**RE: Advanced Auto Parts
Grading and Drainage Plan
Engineer's Stamp Date 9-15-2015 (File: H14D041)**

**RE: Advanced Auto Parts
Grading and Drainage Plan
Engineer's Stamp Date 8-17-2015 (File: H14D041)**

GRADING AND
DRAINAGE PLAN

C-001

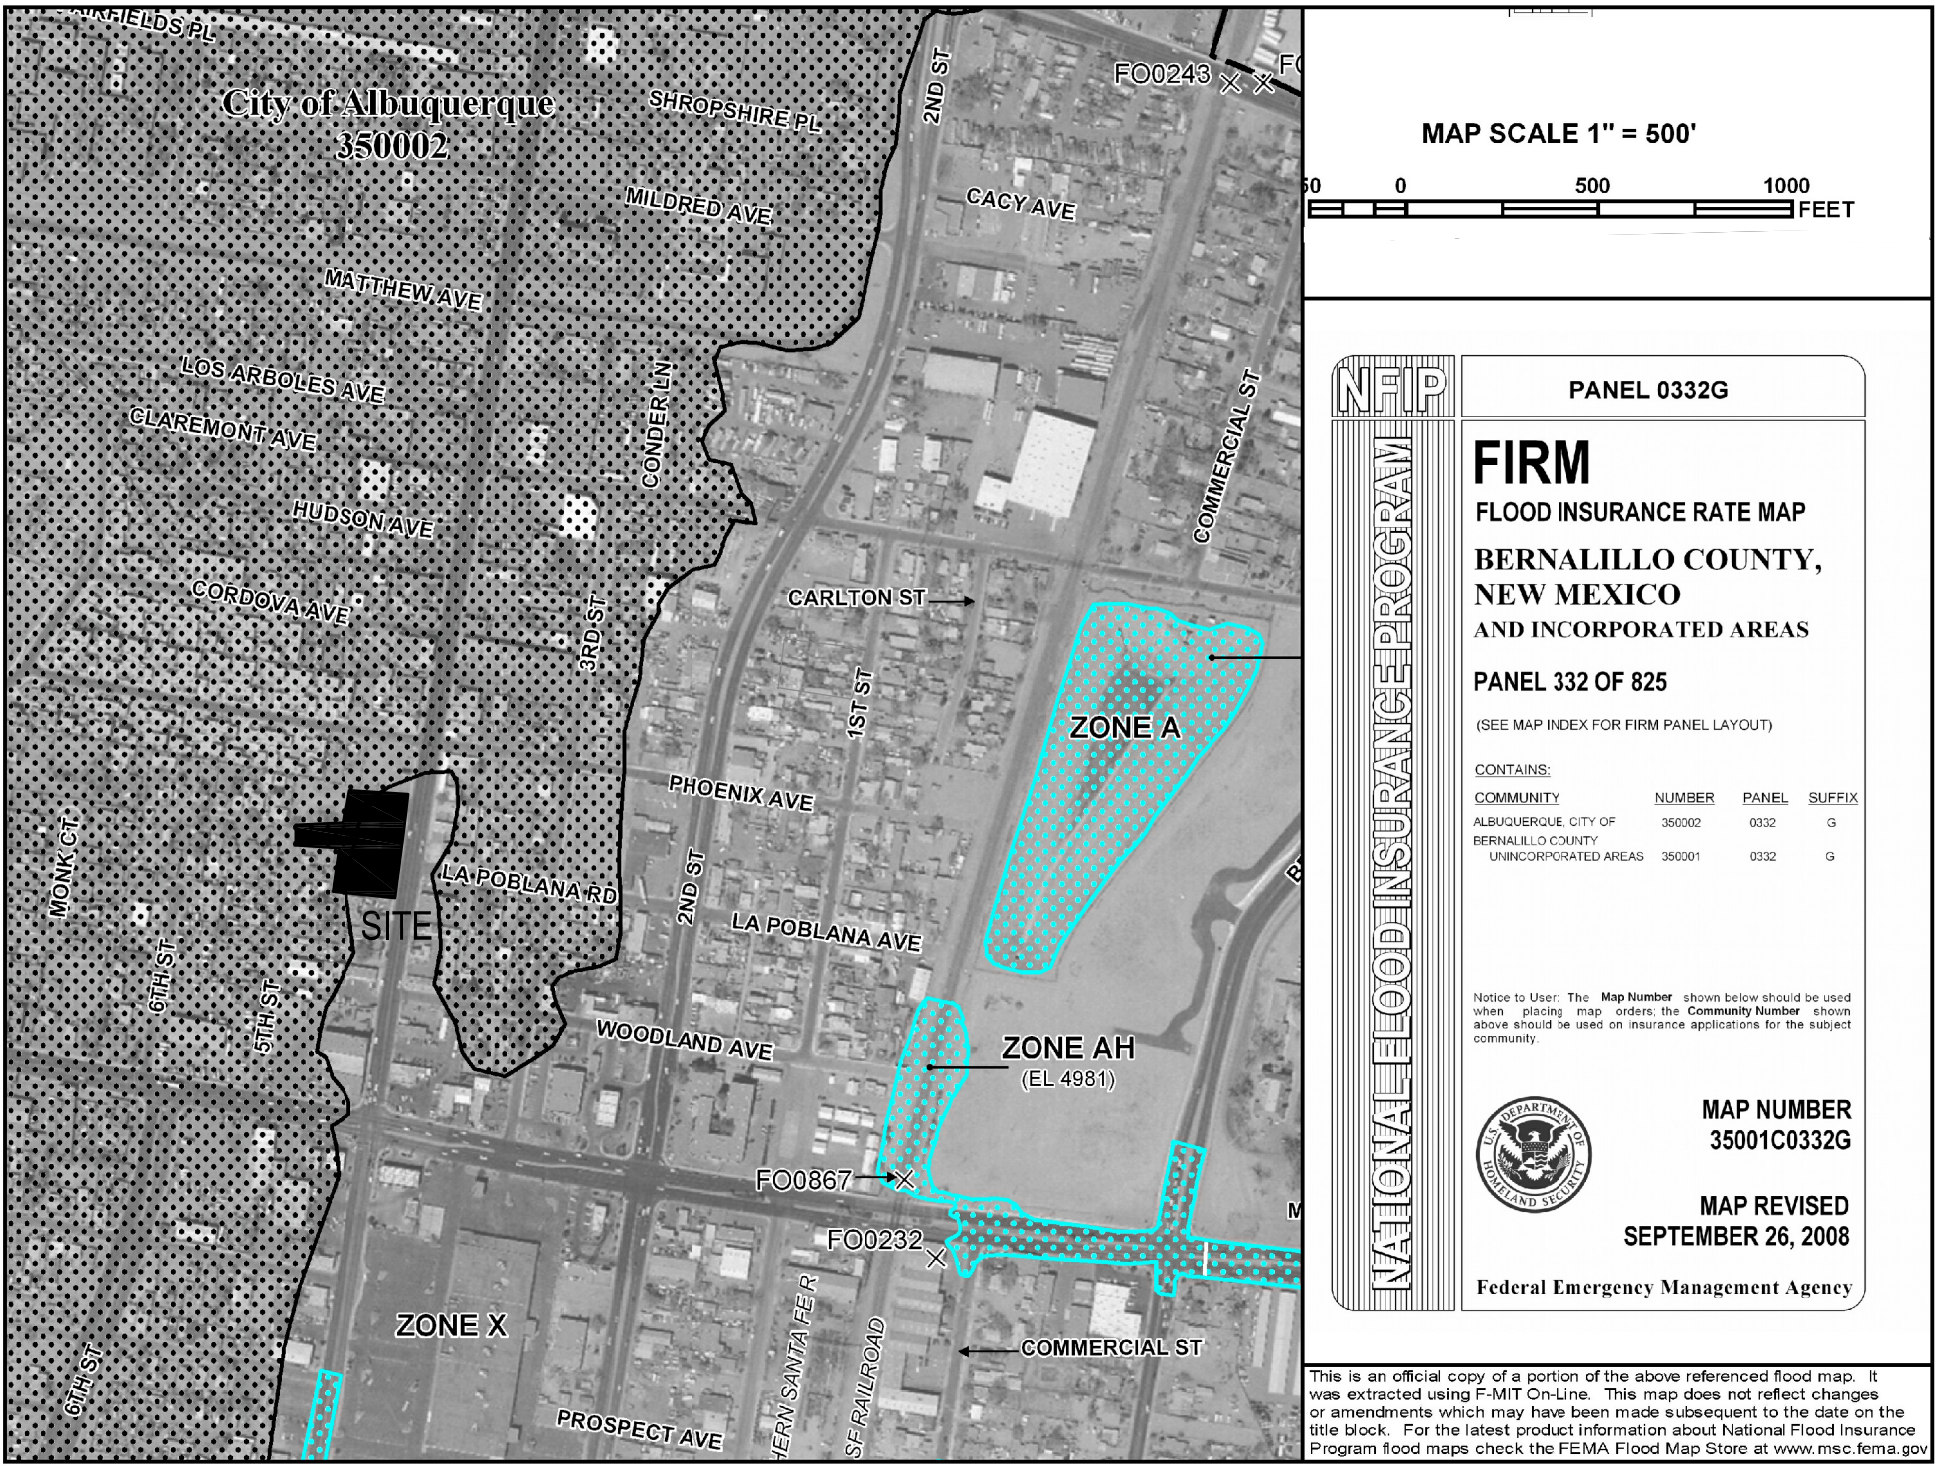
- v. Since full Retention ponds must retain the 100yr-10day volume, with 1 ft. of freeboard, Pond #1 is undersized.

Please see Sheet C-001 for the calculations for the 100yr-10day required volume and the pond volume calculations for Pond #1, showing it retains the required volume at 64.5 elevation which is 1' below the spillway (freeboard). See Sheet C-102 for the newly designed Pond #1.

0-101

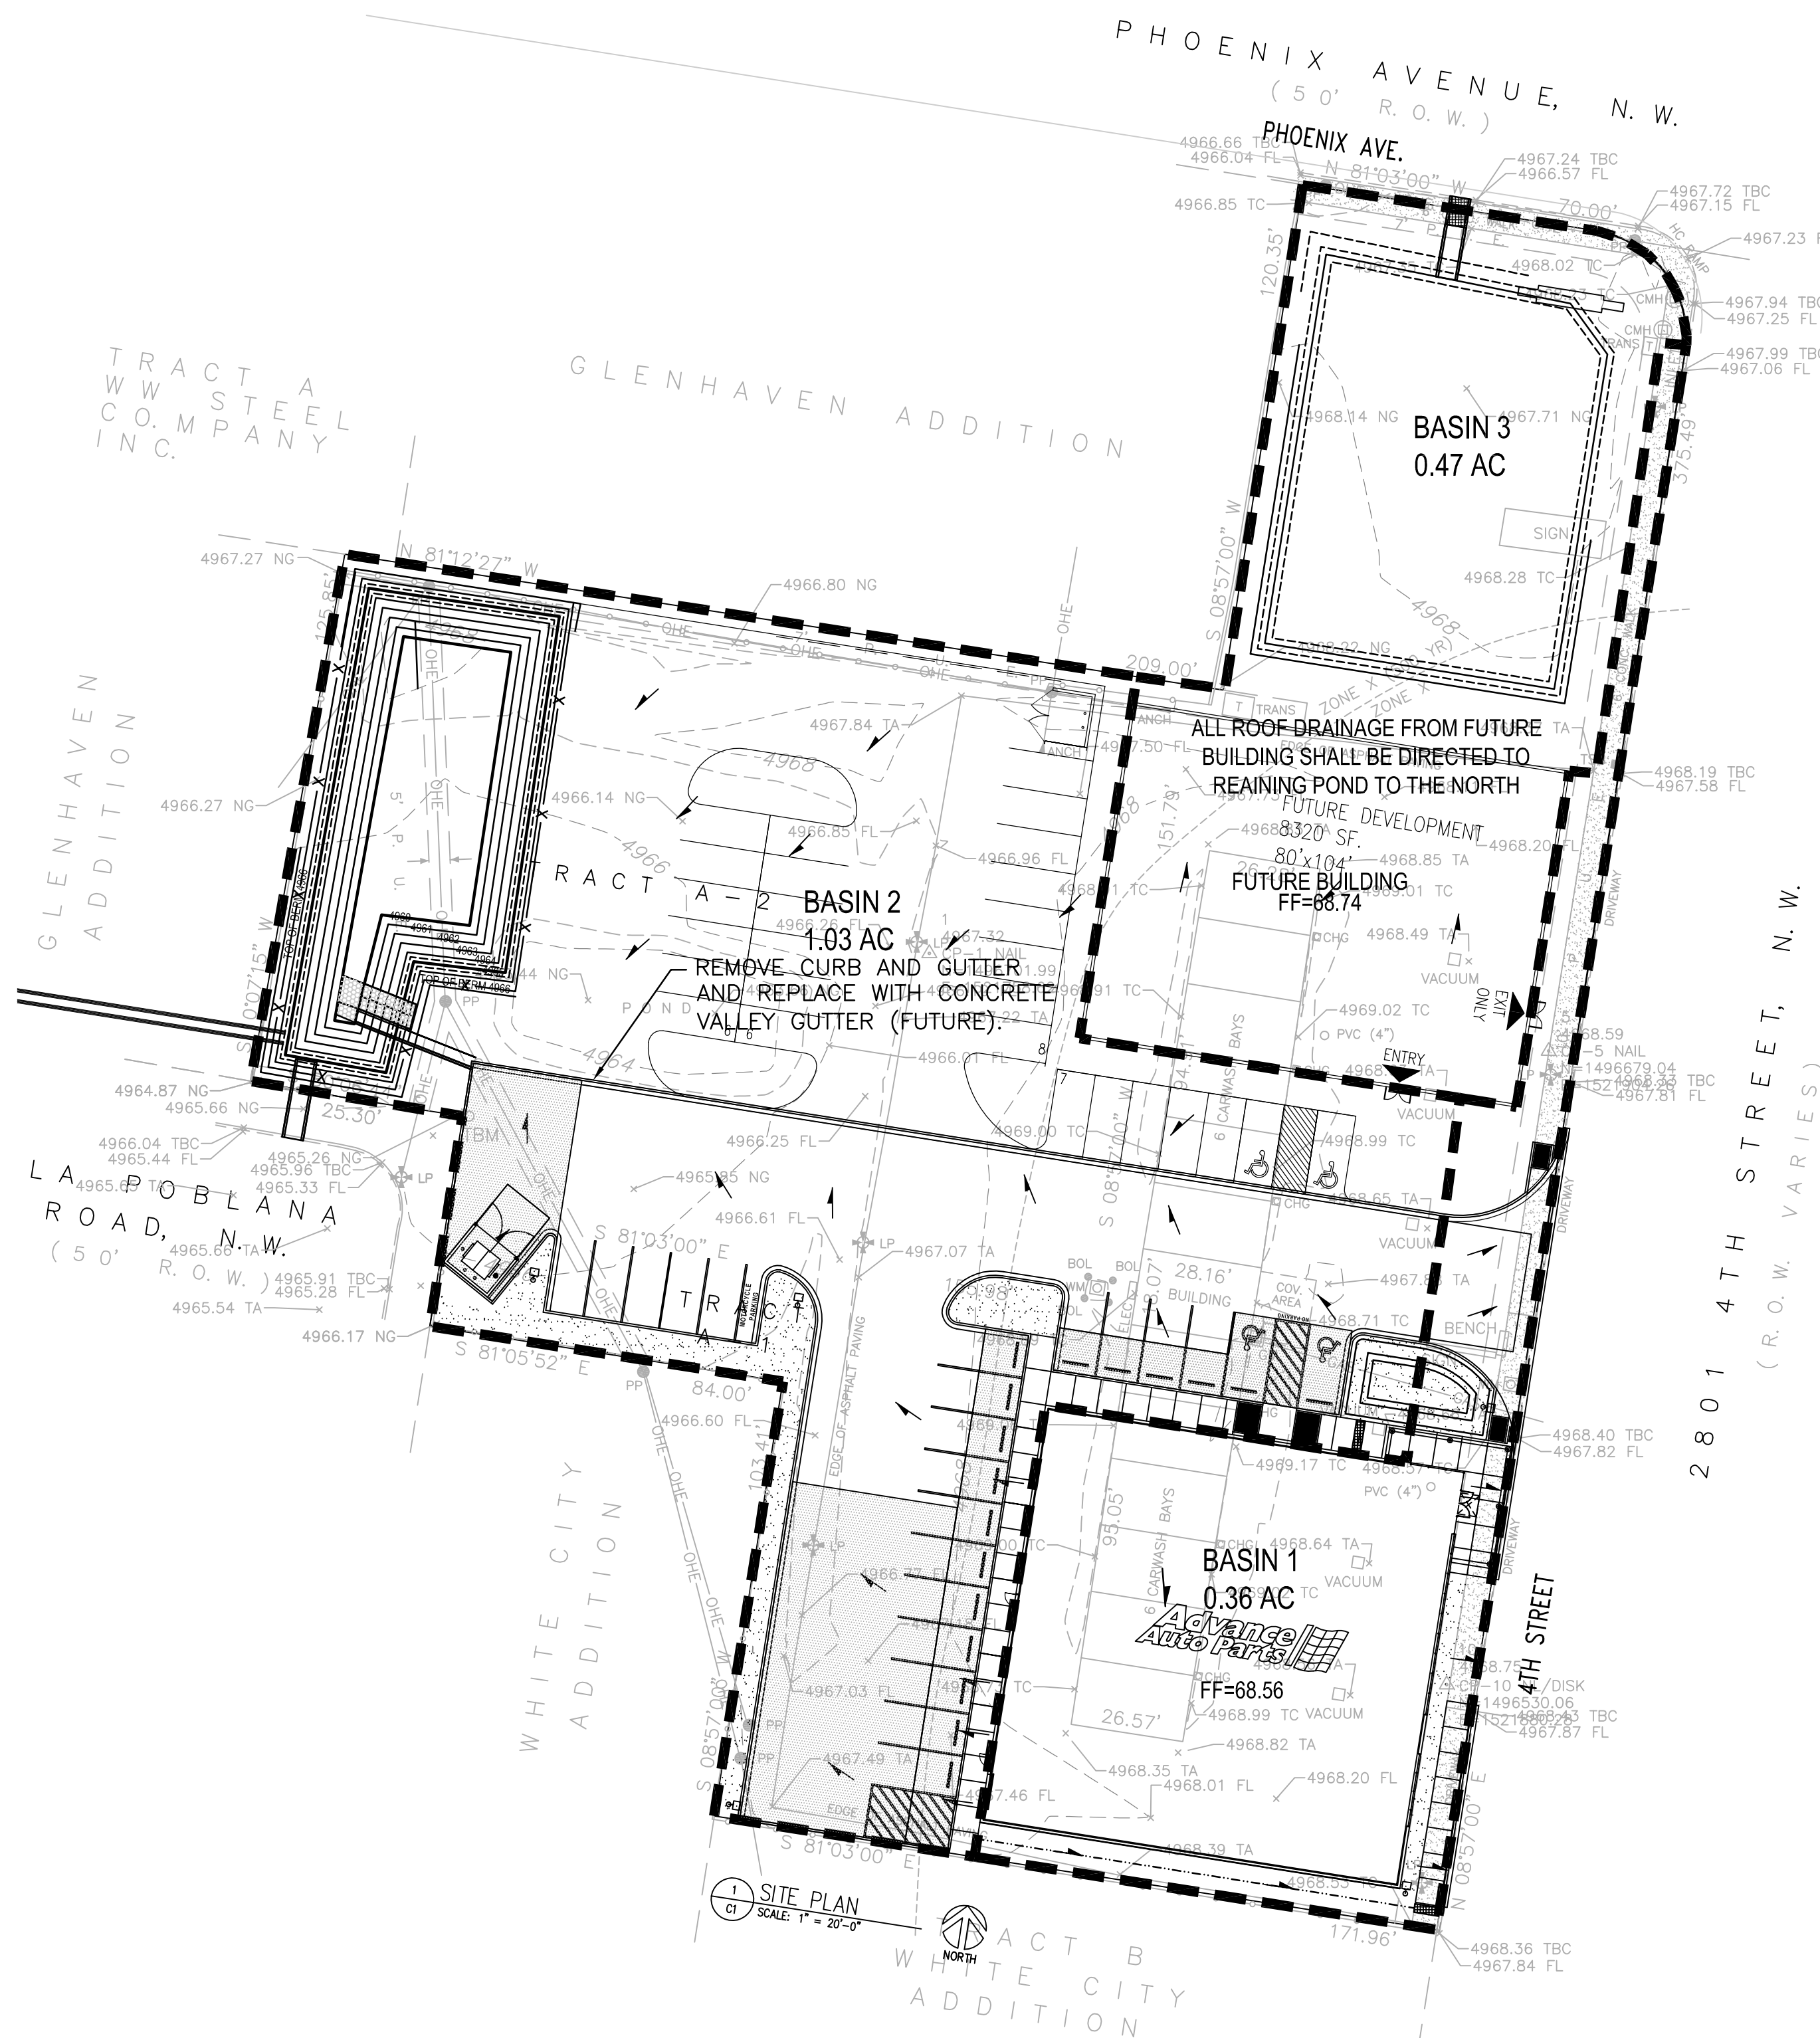
- ii. Show intended elevations/contours in the future parking lot.

- iii. How will flows be directed to the pond in the final condition without the curb and gutter?

- iv. Show the intended roof discharge points and direction of the future building.
Please see sheet C-101 for future building roof discharge points and the direction of the roof flows.

Please see sheet C-101, for future flow arrows and future finish floor on building. This plan shows the general drainage concept of the future development.

C-102

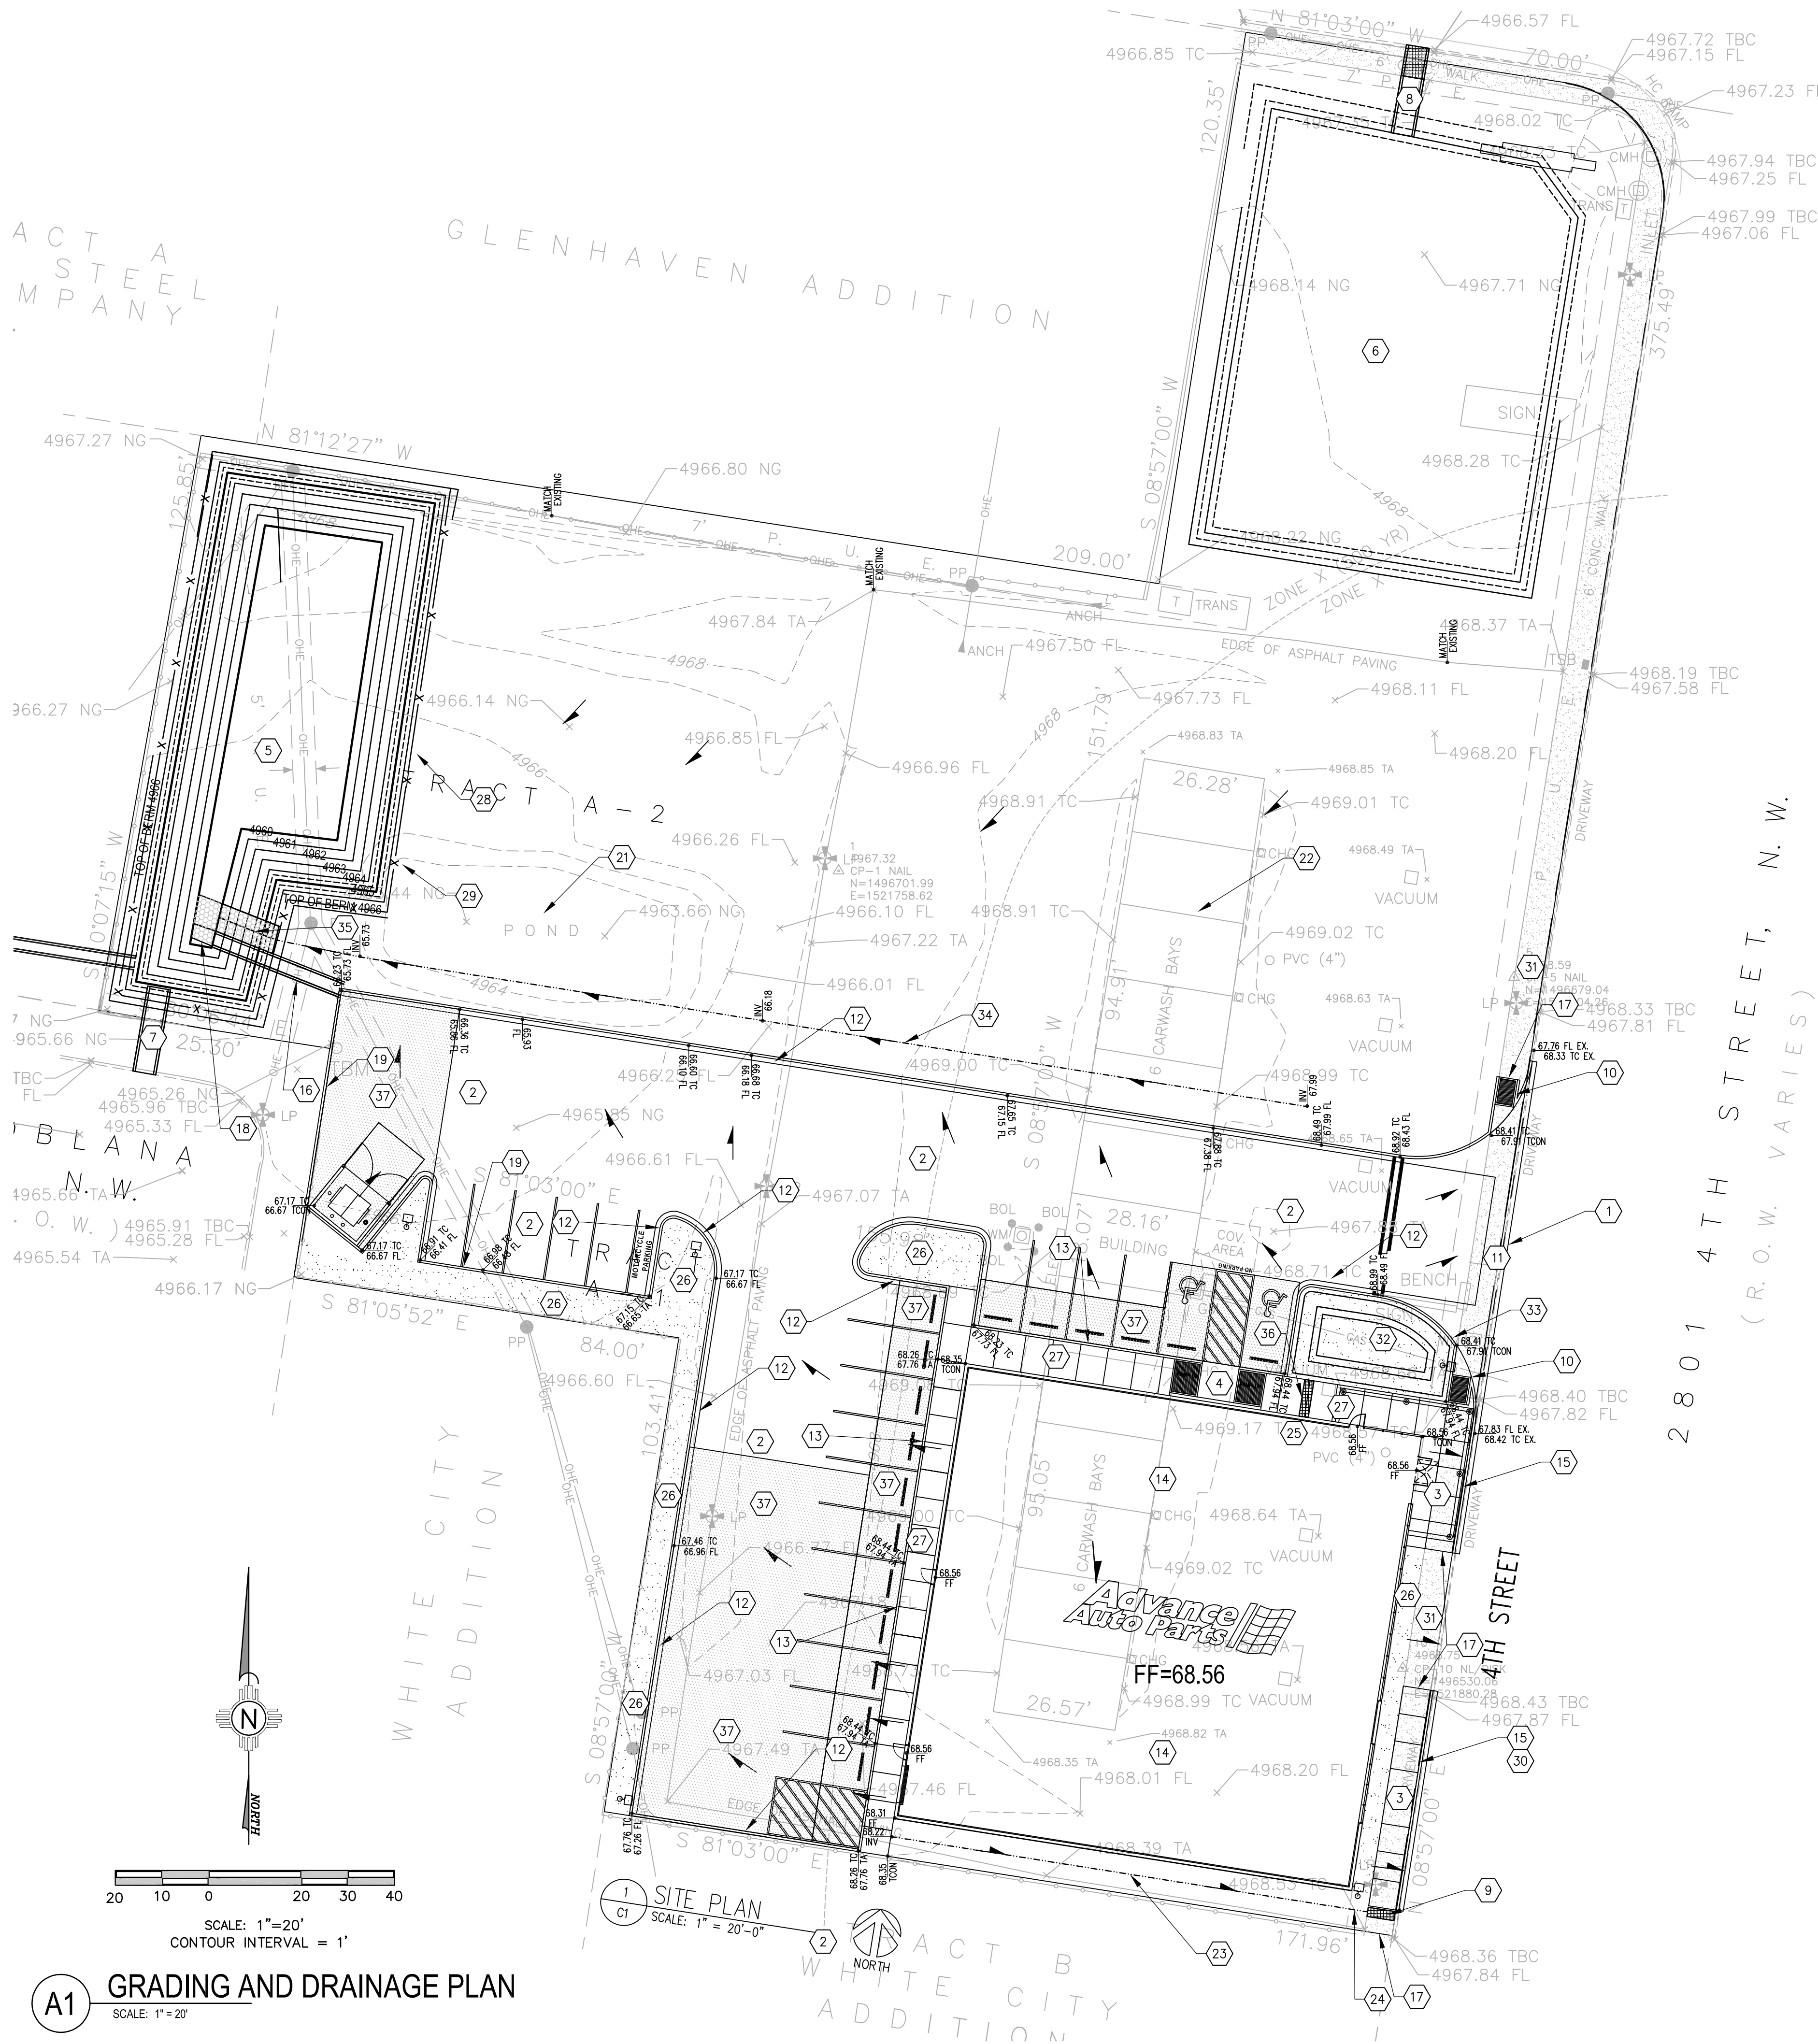
1. Keyed note #9 must be modified to add that the SW culvert (both plate and channel) must be extended 2ft. past the back of Sidewalk. Note that the bolts must be tack welded to the plate.
2. Keyed note #7 must be modified. An open concrete channel presents a tripping hazard. If there is sidewalk, then a Sidewalk culvert should be used (extended per above comment). It is unclear if there is Sidewalk. If there is not sidewalk, then the channel should be an earthen channel filled with riprap to avoid falling into it.

2. This is a "phased" project where one portion of the site is to be developed at this time, and the remaining portion is to be developed in the future. For phased projects the following is required:
 - a. Grading and Drainage plan with supporting calculation for the **Final Developed condition**. Dwg. C-102 is essentially this Final Condition Plan. However, the following needs to be corrected:

- i. Remove the Curb and Gutter separating the two properties, and show only the intended final condition.

- b. Grading and Drainage plan with supporting calculations for the **Interim condition**. Provide a plan with just the development intended to occur under this Building Permit. Show.

- ii. How will the remaining site be graded in the interim? How and where will it discharge to?

3. For both Ponds: Show contour labels, Bottom of Pond elevation, Max WSEL, Provided Volume and Required Volume. (Show this on both the Interim and Future G&D plans, as it may be different :
See sheet C-102 for contours and key notes for Pond information.

4. Roof flows from the Advance Auto Parts must be directed to a first flush pond before discharging to swale along the south boundary. Perhaps the hatched area (handicap ramp?) at SW corner of the building can be used as such:
See sheet C-102. Roof drains diverted to northeast corner of new building then diverted into new first flush Pond #3.

This new curb and gutter will need to be installed as part of the current phase to divert storm water to the new Retention pond. Once phase 2 is developed the Curb and Gutter will be removed and replaced with new Concrete Valley Gutter that will receive storm water from the north and the south and divert into new retention pond. See sheet C-101.

There will be a ditch that will divert water from the north to the new retention Pond #1. See sheet C-102.

6. Keyed notes should refer to the Detail on the Sheet C-501 (ie. See Detail D4 on Sht C-501):
See key notes on sheet C-102 and details on sheet C-501.
7. Pond #2 has a 2:1 slope. More than a 3:1 slope required slope stabilization measures. Large cobbles are typically used.:
6" of 2"-3" cobble stones will be used for stabilization measures. See sheet C-102 for key note and C-501 for detail.
